ANN ARBOR HISTORIC DISTRICT COMMISSION

Staff Report

ADDRESS: 534 N State Street, Application Number HDC 14-176

APPLICATION: The applicant seeks HDC approval to modify a basement egress window into a door and enlarge the well.

534 N State (2014 courtesy Zillow)

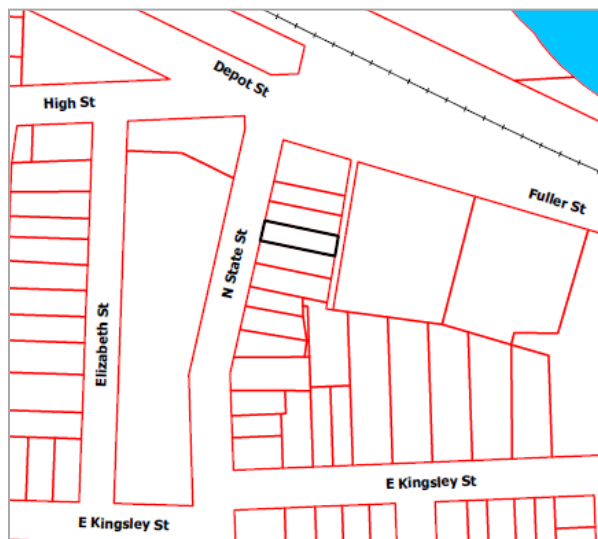
1. The new owners discovered upon move-in that it is impossible to remove the old washer and dryer from the basement because the stairs were reconfigured at some point. Rather than remodel the interior basement stairs, the owners would like to enlarge an existing egress window opening on the south side into an egress door. Staff reviewed other possible locations closer to the rear of the house, but none were satisfactory. The rear basement window is too close to an existing underground cistern, and the other window on the south elevation has mechanical equipment on the inside of the wall. The north elevation drops off steeply from a very thick concrete slab that makes it unsuitable for a new well.

2. The egress window opening is currently 30" wide and approximately 30" tall. The window well is 32" wide and 33" from the wall, and approximately 20" deep. The proposed steel door would be 36" wide and 6'8" tall, with a single full-height lite. The enlarged well would be 44" wide, extend 42" from the house, and be deep enough to accommodate the door. Eight steps would climb up along the side of the house, toward the rear. The new well

would be constructed of 6" x 6" landscaping timbers. A 1" steel handrail would be mounted on the side of the steps away from the house.

- Staff feels that the installation of the door is a needed amenity and minimally intrusive on the historic structure. The window is not original, has already been enlarged, and already has a well. No significant historic materials will be lost, and since the house is on a hill above the sidewalk, the work should not be visible from the street. Therefore, staff believes the proposal meets the *Secretary of the Interior's Standards and Guidelines*, and the *Ann Arbor Historic District Design Guidelines* and recommends approval.
